July 3, 2025

PROJECT NAME: HOMESTEAD VILLAS

PROJECT NUMBER: 2025050088

APPLICATION: REZONING TO PUD WITH CONCEPT PLAN #32957

DETAILS

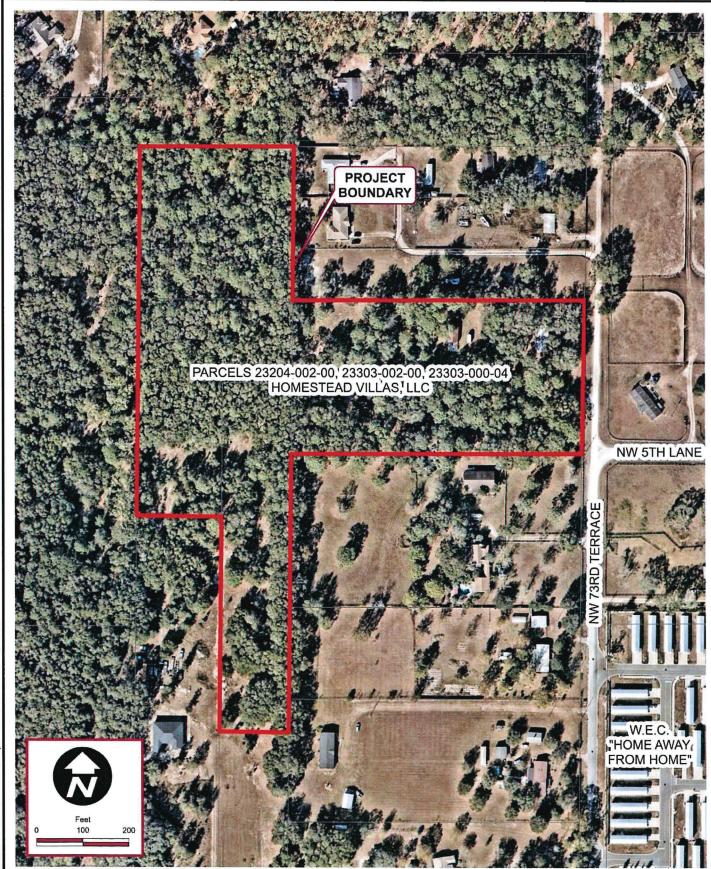
REMARKS: Shown on CO3 Details. If applicant proposes to allow any accessory structures, show the accessory structure setbacks on the lot typical for next submittal.

REMARKS: Renderings shown on C03 Details.

Staff recommends providing landscape renderings that show the differences in height/appearance of the planted buffers at time of planting, 1 year of maturity, and 3 years of maturity. If the applicant chooses to provide these renderings, the applicant should provide the renderings to staff by 5 business days (8/18/25) before this application's expected Planning & Zoning Commission hearing date on 8/25/2025.

Figure 2: Typical Building Elevation

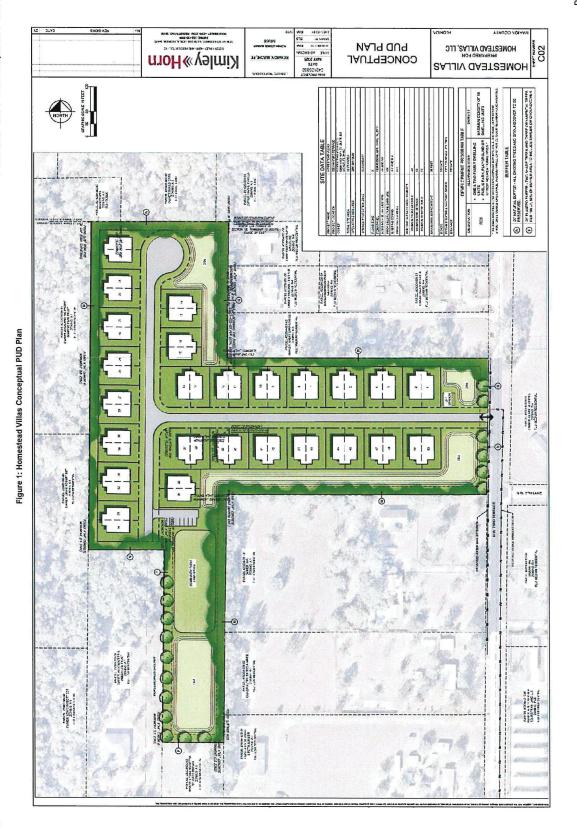
Per 4.2.31.E(4)(a)3., indicate the height of the proposed building on the provided typical building elevation. The applicant may wish to illustrate how the proposed building height compares to the height of neighboring residences to further support the applicant's claim of use/character compatibility.

Figure 4: Community Park/Open Space

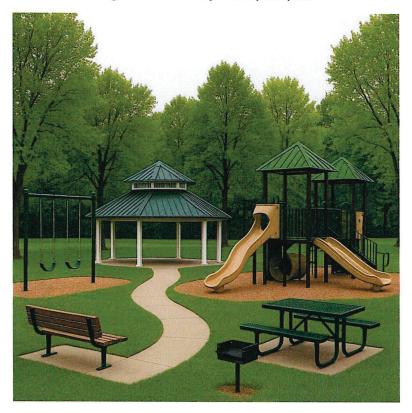
REMARKS: Proposed community area/park is provided on C02 Conceptual PUD Plan. Renderings of potential park facilities shown on C03 Details. The "Project Background" document states 1.0-acre park size; however, the park size is not noted on the concept plan.

- [1] Add anticipated park acreage to the C02 Conceptual PUD Plan with next submittal. Also add the approximate calculations for expected DRAs as this is relevant for Sec 4.2.31.E.(7)(d)3.
- [2] Provide acreage break down of open space as DRA, Natural Buffer, Planted Buffer, Community Park/Open Space. This will be a part of the front-page requirements from Sec. 2.12.4.L
- 44 DEPARTMENT: ZONE ZONING DEPARTMENT

Figure 5: Typical Roadway Section

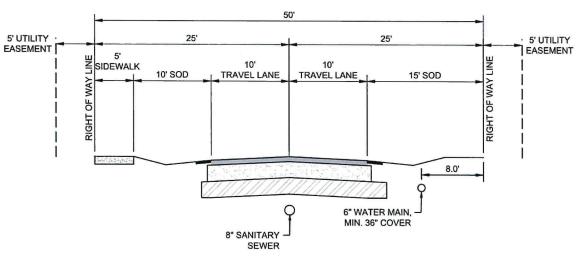
- [2] Pedestrian circulation is not shown on C02 Conceptual PUD Plan, but the typical section shown on C03 Details labels 5' sidewalk on one side of the street. It is not clear residents would walk to the proposed community space discussed in the applicant's PUD Standards document (page 2) or walk to the potential cross access connectivity discussed in input comment [1]. The preliminary sidewalk location is a requirement for PUD conceptual plan review (see 4.2.31.F(2)(B)14. Provide the location prior to Planning & Zoning Commissioner hearing date.
